# Access Compliance Report

## Public Rights-of-Way

Intersection ID: N/A	Main Street: STEELE_CREEK_RD	Cross Street: BEREWICK_COMMONS_PY	Location: NW
ADA ID: 562EAC2EB8BC	Ramp Type: PerpDiag	Initial Pass/Fail: Fail	Overall Compliance: No
		Severity Score: 12.5

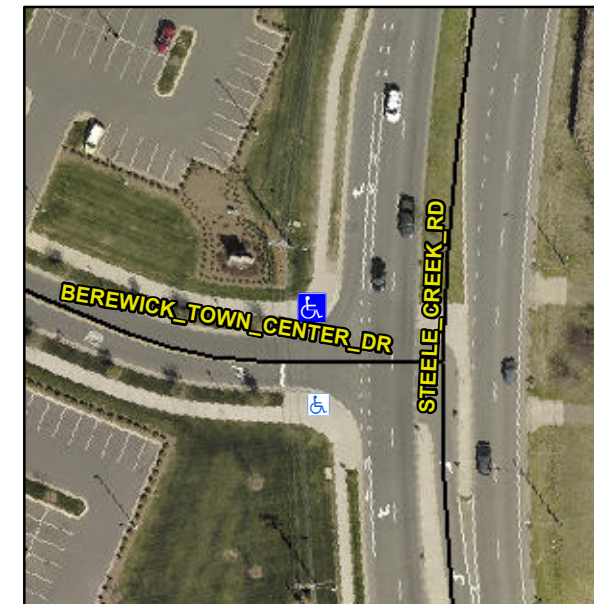
**Not Found, R304.5.3**

Compliance	Description	Data	Compliance	Description	Data
N/A	Ramp Length (in)	86.0	Yes	Ramp Slope (%)	6.0
Yes	Ramp Width (in)	48.0	No	Ramp XSlope (%)	6.6
N/A	Flare Type LT	N/A	N/A	Flare Type RT	N/A
N/A	Flare Slope LT (%)	N/A	N/A	Flare Slope RT (%)	N/A
N/A	Flare Traversable LT?	N/A	N/A	Flare Traversable RT?	N/A
N/A	Landing Length (in)	N/A	N/A	DWS Provided?	N/A
N/A	Landing Width (in)	N/A	N/A	DWS Contrast?	N/A
N/A	Landing Slope (%)	N/A	N/A	DWS Length (in)	N/A
N/A	Landing X Slope (%)	N/A	N/A	DWS Full Width?	N/A
N/A	Landing Curb? (Y/N)	N/A	N/A	DWS Offset (in)	N/A
N/A	Shared Landing?	N/A			
N/A	Gutter Ponding?	N/A	N/A	Gutter Slope (%)	N/A
N/A	Gutter Lip Ht (in)	N/A	N/A	Gutter X Slope (%)	N/A
N/A	Painted X Walk1?	No	N/A	Painted X Walk2?	No
	X Walk 1 Direction	To S		X Walk 2 Direction	To SE
N/A	X Walk 1 Width (in)	N/A	N/A	X Walk 2 Width (in)	N/A
	X Walk 1 Slope (%)	3.5		X Walk 2 Slope (%)	2.5
	X Walk 1 X Slope (%)	2.8		X Walk 2 X Slope (%)	3.6

**Remove & Replace Curb Ramp With Two New Directional Ramps or Equivalent.**
